# Illinois Department of Transportation

## Memorandum

To: ALL BRIDGE DESIGNERS 05.1  
From: Ralph E. Anderson *Ralph E. Anderson*  
Subject: Lifting Loops for PPC I-Beams and Bulb-T Beams  
Date: January 26, 2005

Figure 1.4.25

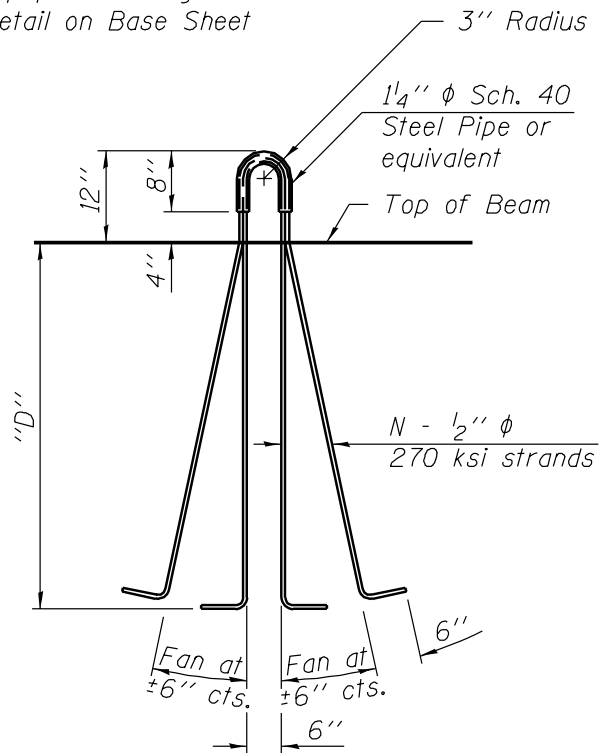
1. The strand selection charts were revised for the lifting loops to reflect the latest reduced design capacity of a strand.
2. The minimum permissible angle of lift was increased from 45 to 60 degrees.

3. A pipe was added around the top portion of the strands in the lifting loop. This helps ensure that all strands are equally engaged during the lifting process and it also helps hold the configuration of the lifting loop for easier fabrication.

4. A note was added to the base sheets requiring a minimum 2 ½ inch diameter lifting pin. The lifting pin helps to prevent localized overstress of the lifting loop strands during handling.

5. The projection above the beam and the radius of the lifting loop were revised. The new geometric configuration is more consistent with the design load path and provides cleaner handling of the beam.

6. The lifting loops were moved further away from the end of the beam to reduce stress concentrations and to relieve fabrication congestion.

7. The strands within the lifting loop are now flared. This provides full embedment anchorage for each strand within the loop and therefore eliminates the need to use reduction factors for multiple strands.

Attached is a new lifting loop figure which is intended to replace the current Figure 1.4.25 of the Prestressed Concrete Manual. Designers are encouraged to implement the new lifting loop design and details on all projects which have not been let; however, all projects beginning with the June 17, 2005 letting shall utilize the new detail. The following Base Sheets have been revised for the new lifting loop details: (PI-4-36; PI-4-42; PI-4-48; PI-4-54; PBT-4-63; and PBT-4-72). They are dated 1-26-05 and may be found in the MicroStation v8 prestressed cell library on the IDOT web site.
